SUMMARY: DETAIL DESIGN REVIEW

Biodiesel Reactor Improvements
 University of Idaho
 Team Liquid Gold

Meeting: BAE Conference Room, 3:30, 02/26/2015

Mixer Mechanical Design – Fluid Forces
Weetman & Gigas
2002

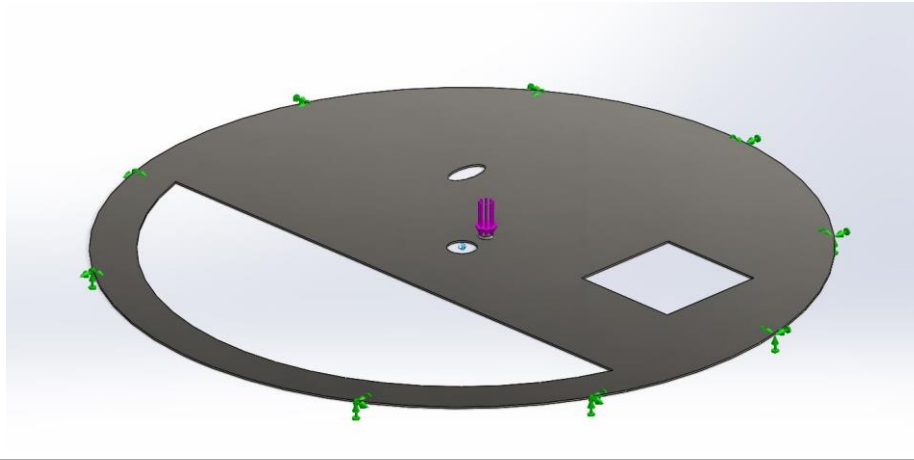
During previous meetings, the clients expressed concerns that the tank lid could develop harmonics from resonant frequencies similar to those of a drum surface. The team presented that experts consider FEA frequency modal analysis of mixers mounted on vessels only essential for mixers over 100 HP. As the system motors are much less than 100 HP, the team elected to consider such an analysis as not necessary. The clients accepted the team’s analysis, but requested that the team treat the lid as a drum surface and find a resonant frequency to avoid during operation.

The team is following up on the questions of bolt specification, drum head resonance, and improved FEA analysis. Viton sealant will be researched, and if appropriate, specified for tank sealing. Further research is being done into design of a system to condense methanol vapors venting from the reaction.

Finite Element Analysis

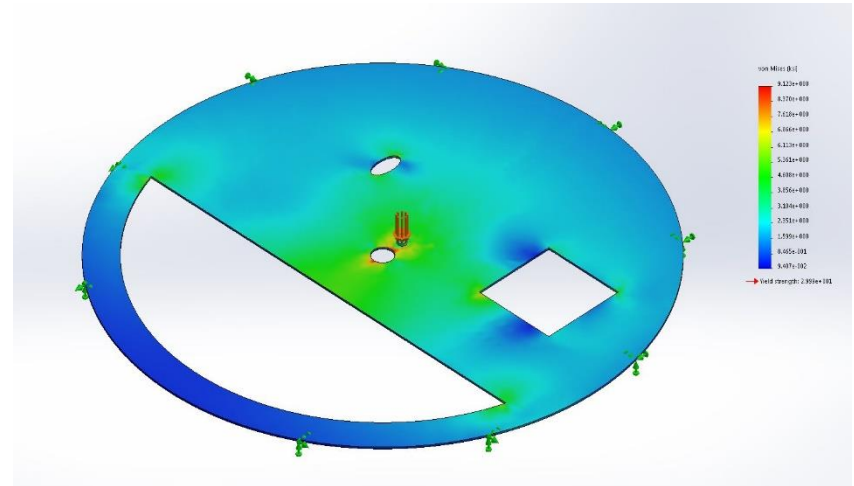
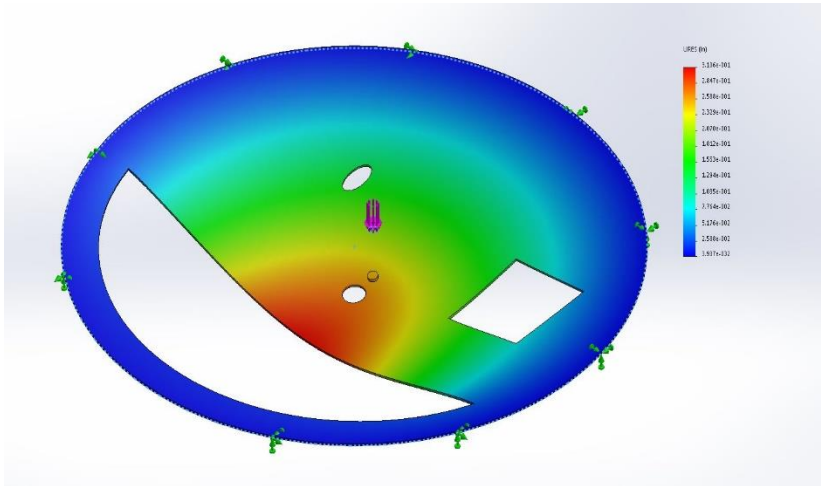
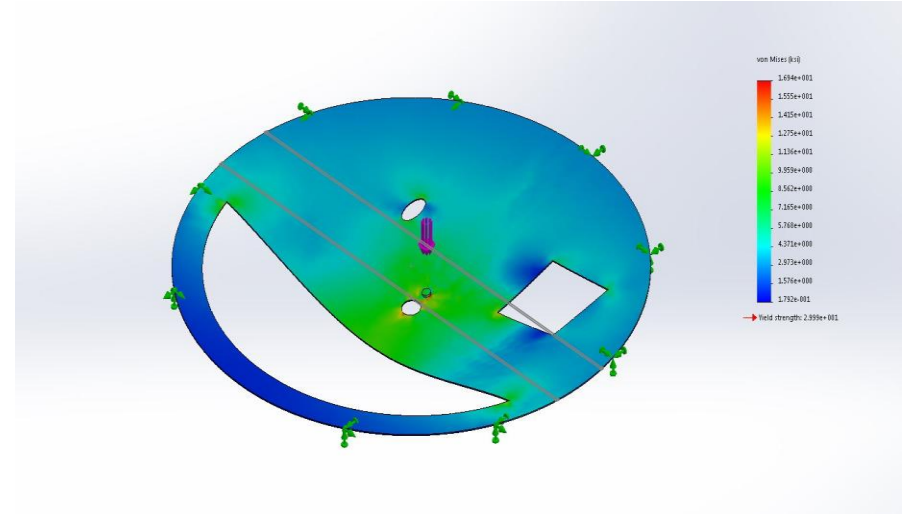
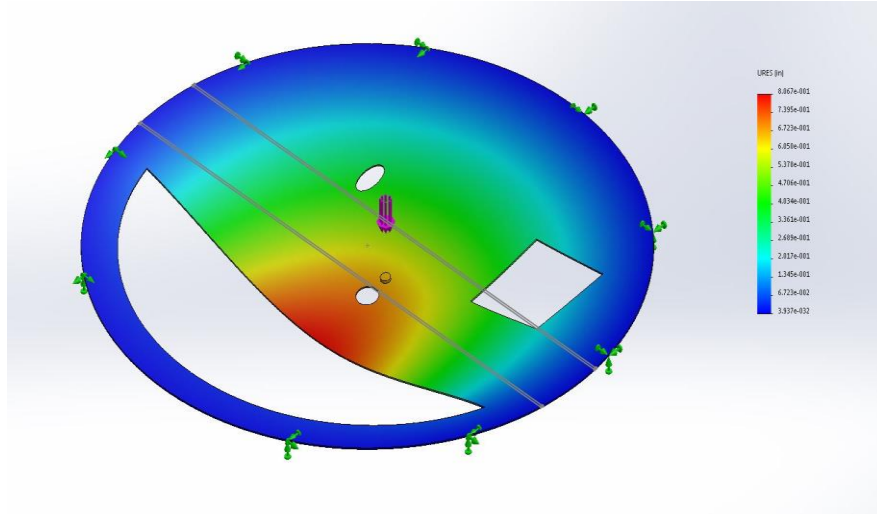
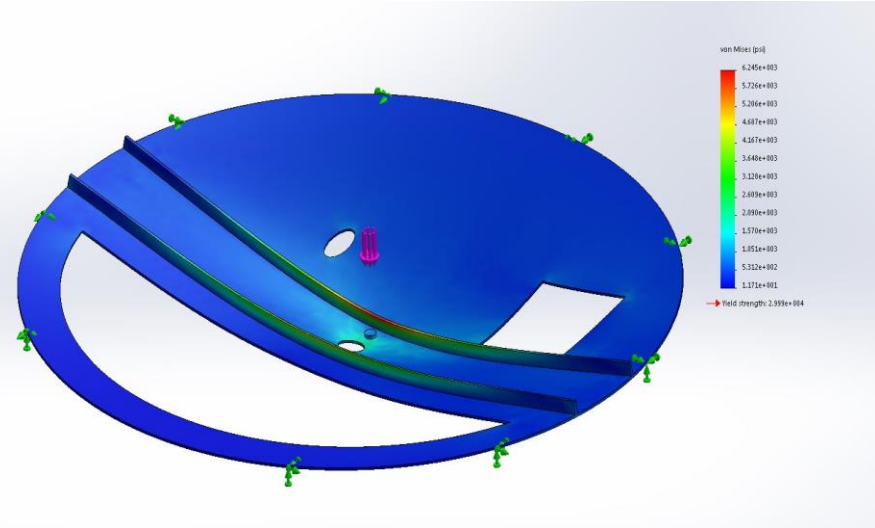
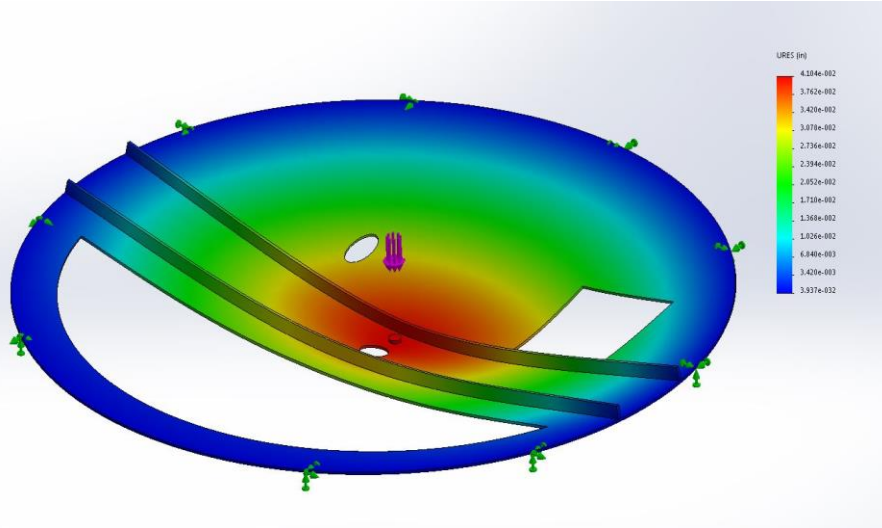
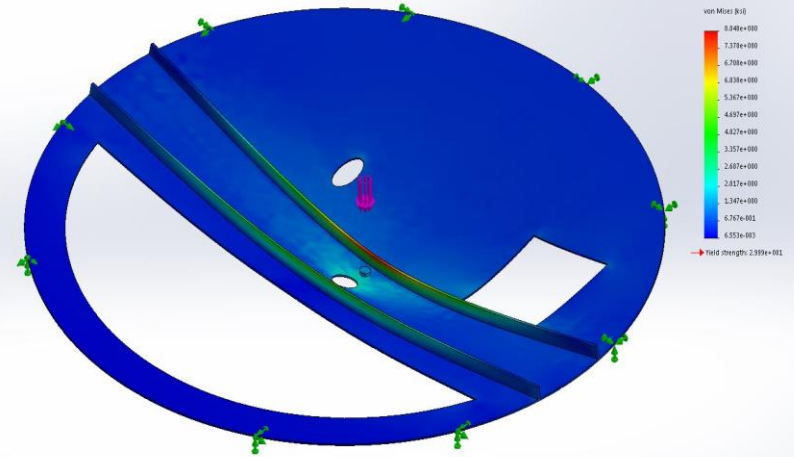
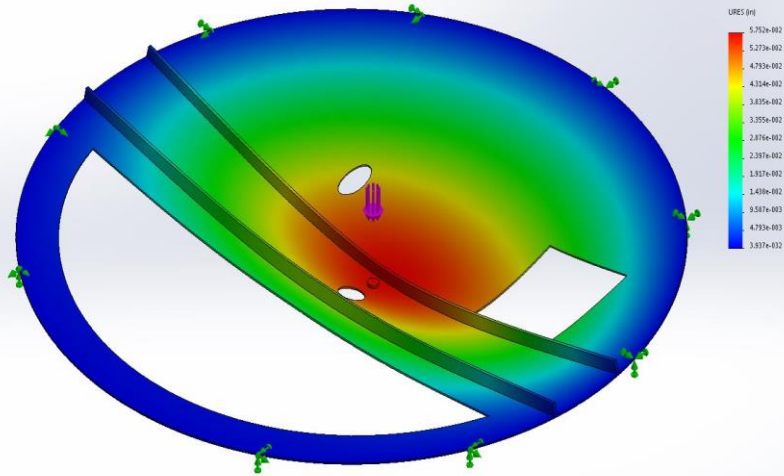
The team presented a finite analysis of four iterations of lid structural design, representing possible combinations of lid sheet thickness and the presence or absence of reinforcing webs. The design as proposed offered minimal stress loading and deflection with 100 pounds force applied at the center of the lid. The client requested that we increase the central loading to 200 pounds force or more in order to reflect upper limit design considerations.

TANK ENCLOSURE

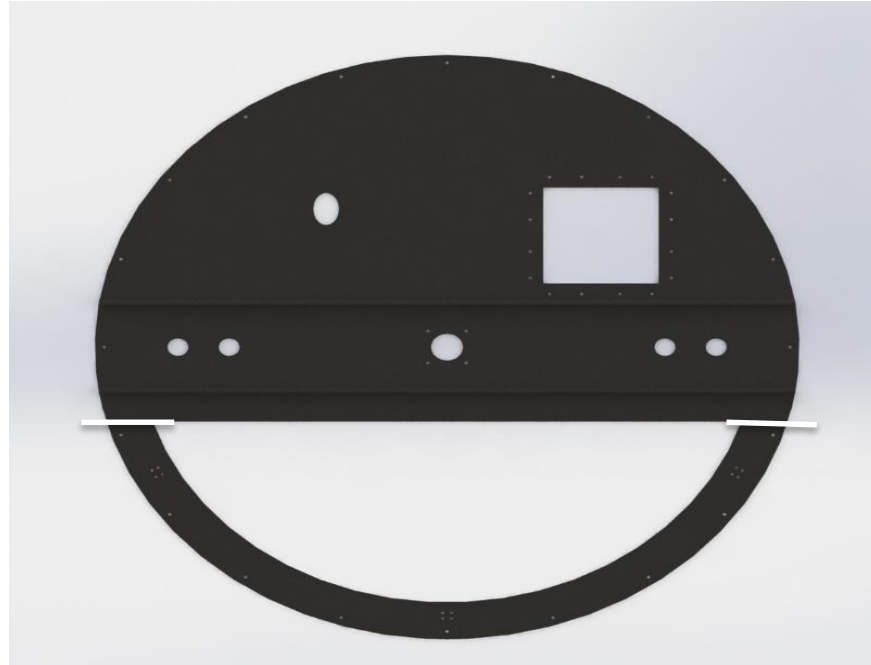
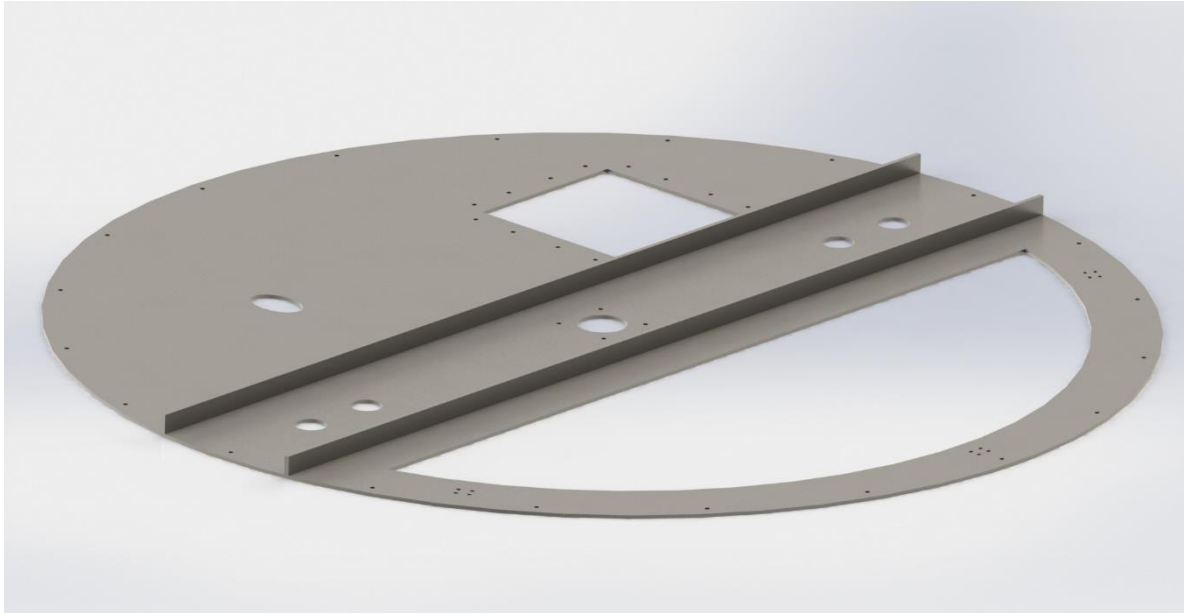
general design, but requested further engineering proof of analysis on the quantity and type of bolt specified to fasten the lid to the existing tank, citing concerns about edge of tank sealing. The clients noted incompatibilities between the proposed sealant (Buna-N) and recommended use of Viton sealants instead.
